Service Letter: 436

Date: June 10, 2011

Title: Installation Floorboard Extensions or Revised Floorboards

Effectivity: 7EC, 7ECA, 7GCAA, 7GCBC, 7KCAB, 8KCAB, and 8GCBC models manufactured before July 1, 2011 as indicated by the aircraft data plate. Aircraft manufactured after July 1, 2011 comply with this service letter.

**Figure 1, Installation - 3-1793-1 Floorboard Extension**  
(Front Left Side Shown)

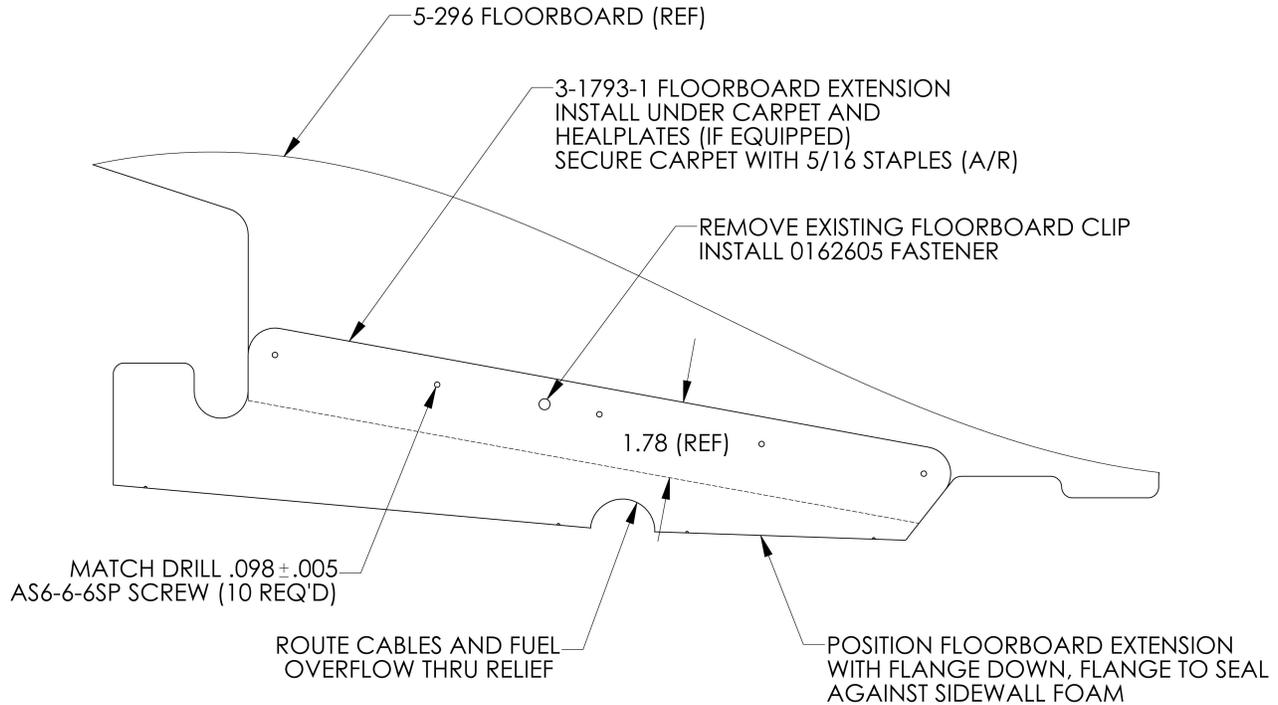
Description: Loose items have been reported to cause control system interference particularly during aerobatic flight. Gaps between the front floorboards and cabin sidewalls may allow loose items to enter the airplane belly.

This service letter provides guidance for either: A) installing floorboard extensions in the left and right forward cabin; or B) replacing the front floorboards with a revised version. Both options provide improved fit with the forward cabin sidewall.

**Option A – Floorboard Extensions (See Figure 1)**

1. Lift carpet to facilitate installation of floorboard extensions. It may be necessary to remove staples securing the carpet to the floorboards.
2. Remove floorboard clips where noted.
3. Position 3-1793-1 floorboard extensions against sidewall.
4. Install 0162605 fasteners through floorboard extensions, floorboards, and fuselage tabs.
5. Match drill  $\varnothing$ .098 holes through floorboard. Secure floorboard extensions with AS6-6-6SP screws.
6. Secure carpet with 5/16" staples.
